POLICY ISSUE
(Notation Vote)

SECY-99-284

FOR: The Commissioners
FROM: William D. Travers
 Executive Director for Operations
SUBJECT: CLASSIFICATION OF SAVANNAH RIVER RESIDUAL TANK WASTE
 AS INCIDENTAL

Figure 4: Tank closure showing layers of fill material [5].

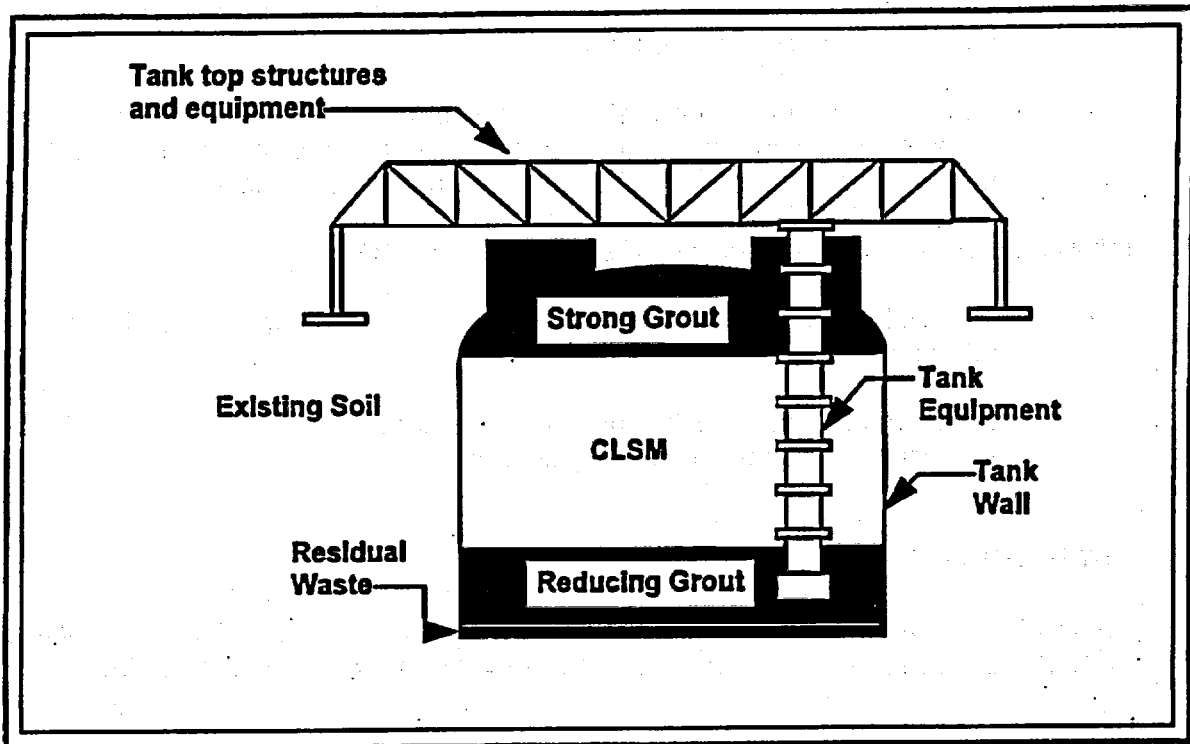
The DOE Closure Plan [2], which has already been implemented for Tanks 17 and 20, includes the addition of a reducing grout to the residual waste in the tank, followed by a layer of low-strength cement, and a layer of high-strength grout. See Figure 4.

The Regulatory Basis [5] addresses the stability of the grout-filled tanks based on three factors (derived from 10 CFR 61.56): (i) resistance to subsidence, (ii) resistance to dispersion, and (iii) reduction of the likelihood of inadvertent intrusion. Assuming that DOE fills the tanks according to the procedures outlined in the Industrial Wastewater Closure Plan [11], the waste will be immobilized in cementitious materials at least 10 m below the ground surface, with the topmost layer consisting of a strong grout.

Figure 5: Tank 20 riser locations [14].

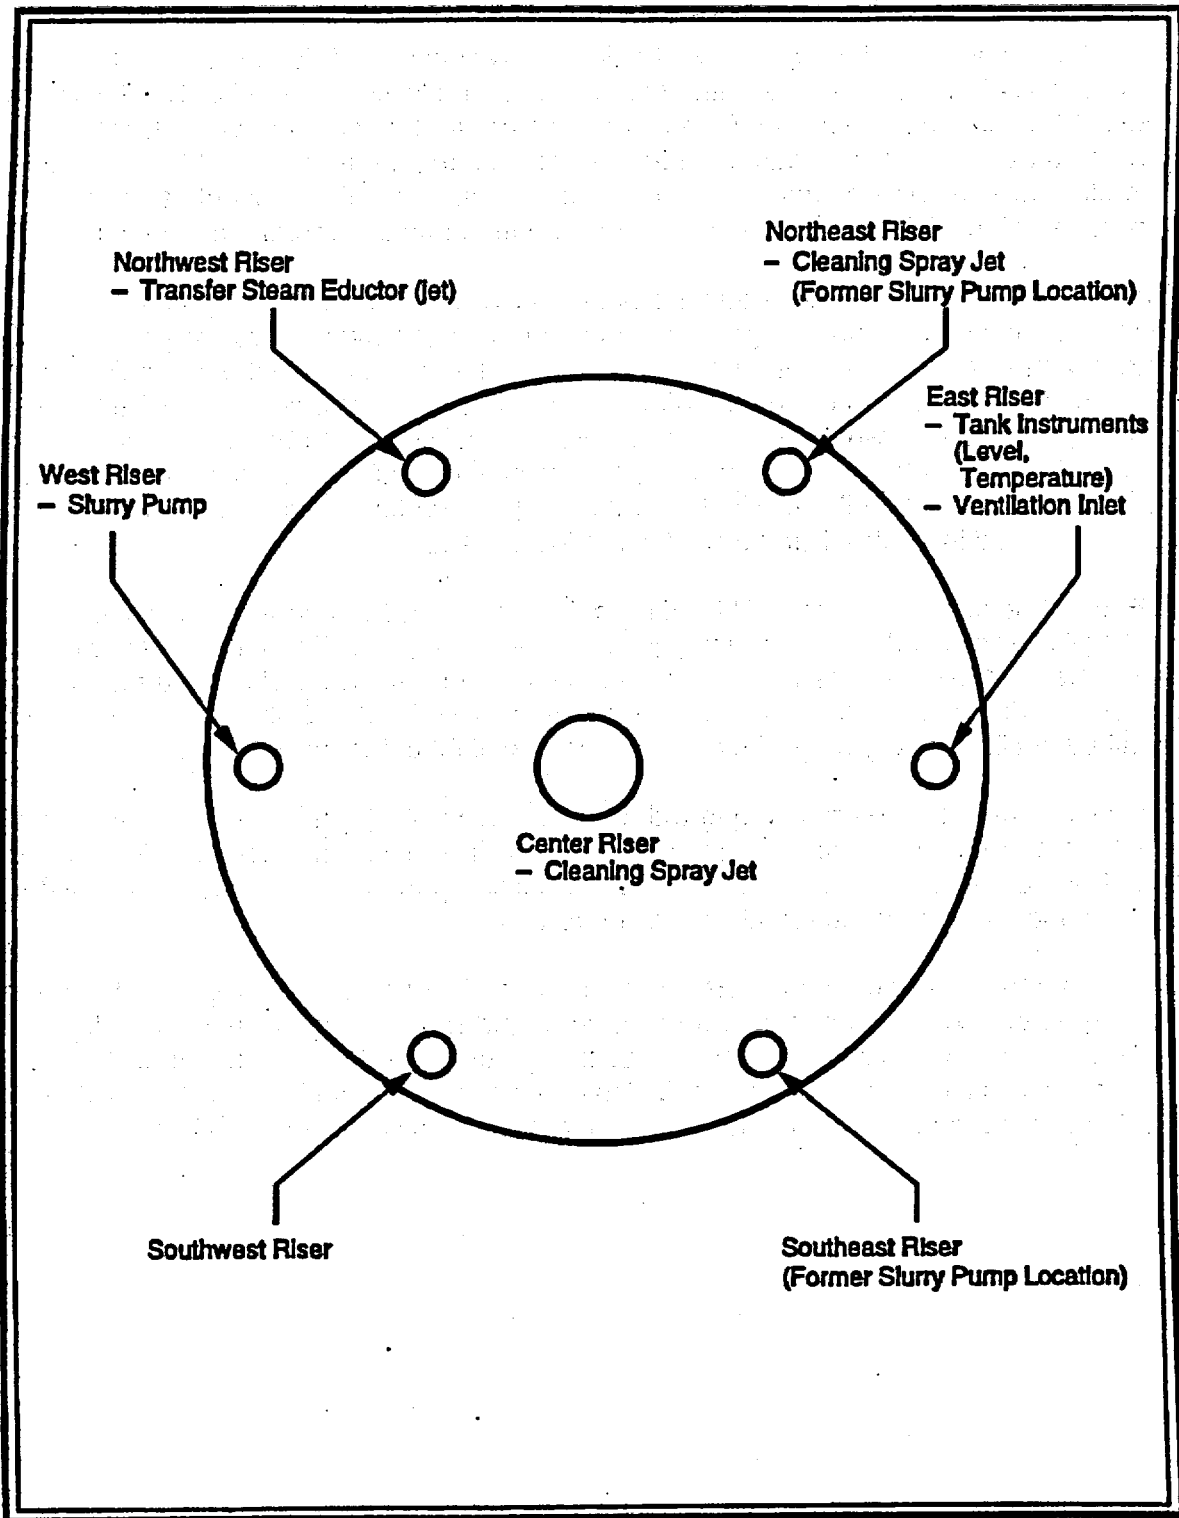
DOE will pump reducing grout directly on to residual waste in the tank from seven tank risers, six around the circumference of the tank, and one in the center (Figure 5). The grout mixes partially with the residual waste, and surrounds it generally in a wagon wheel form (Figure 6). After the liquid grout is poured, dry grout is distributed on top to absorb any remaining liquid, and to fully cover the residual waste. The reducing grout alters the leachate chemistry, and reduces the mobility of certain radionuclides, by creating a reducing environment, with a high pH [5].
